MILITARY SPECIFICATION

BAND, CENTERING FOR PROJECTILE 105MM DISGARDING SABOT

This amendment forms a part of Military Specification MIL-B-48570A (AR), dated 30 October 1979, and is approved by the US Army Armament Research and Development Command and is available for use by all Departments and Agencies of the Department of Defense.

FIGURE 1

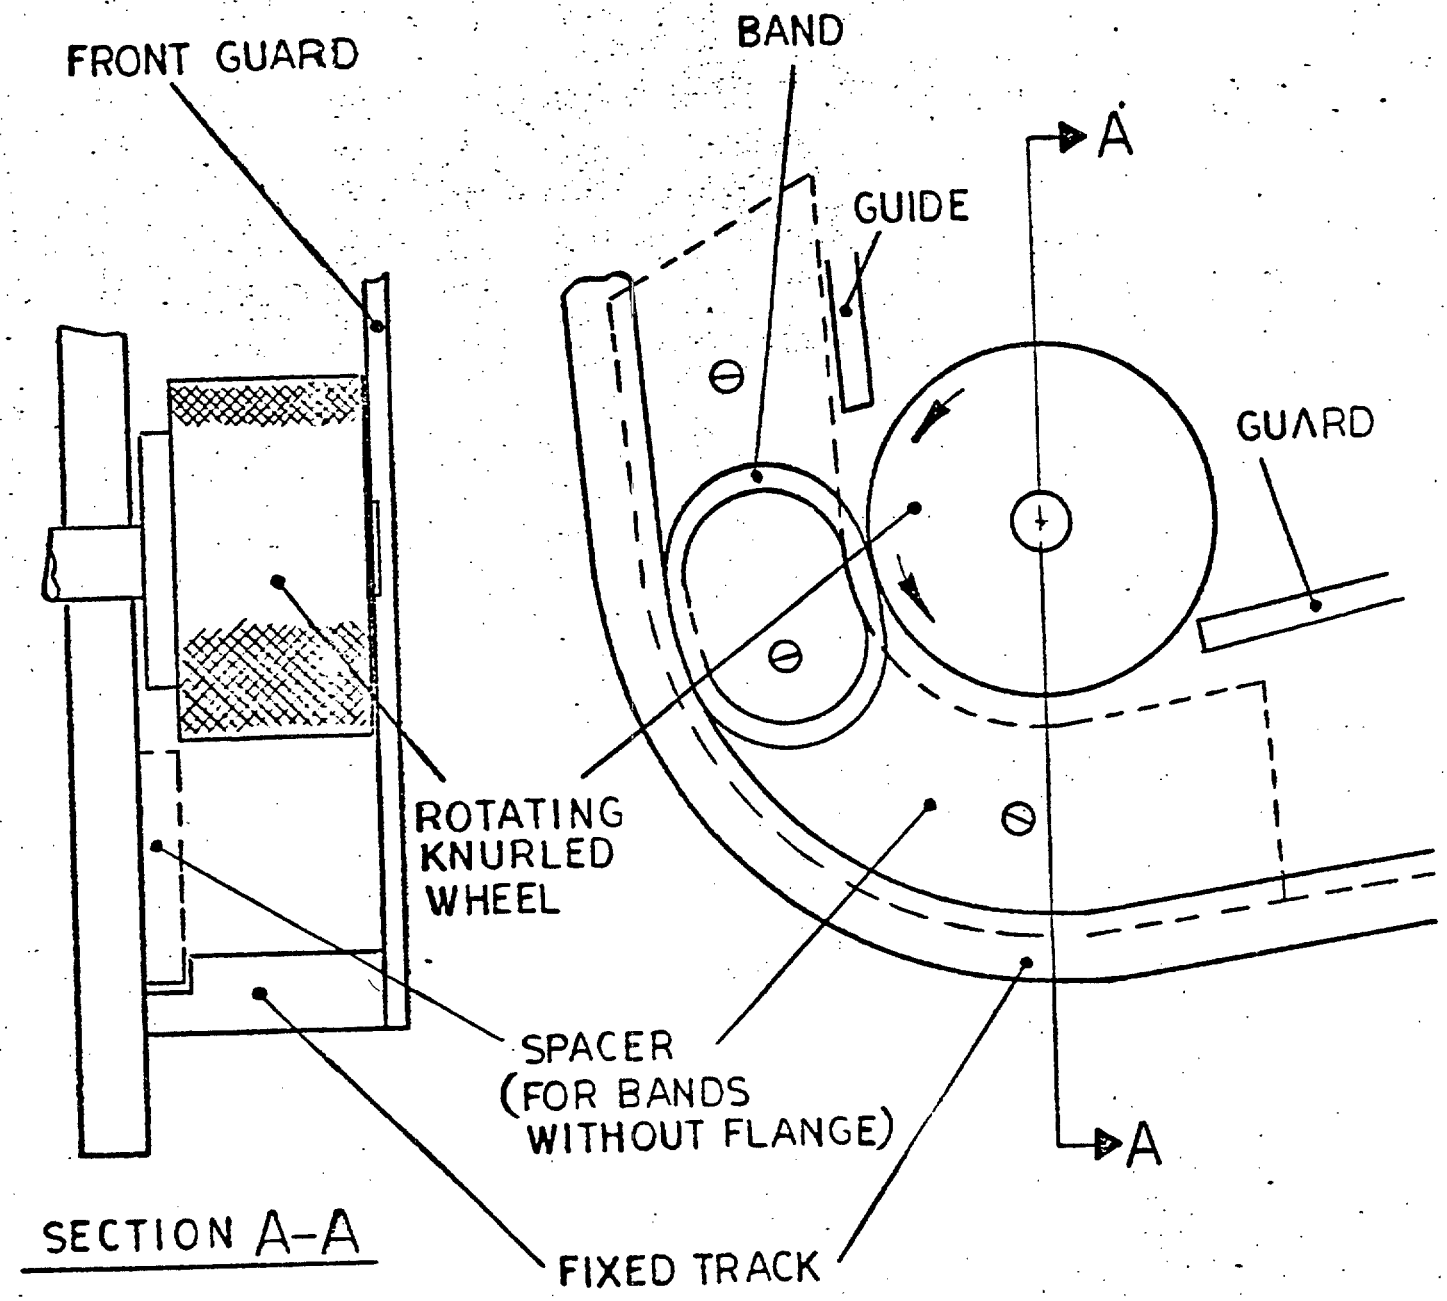
Add page 13 (Figure 1)
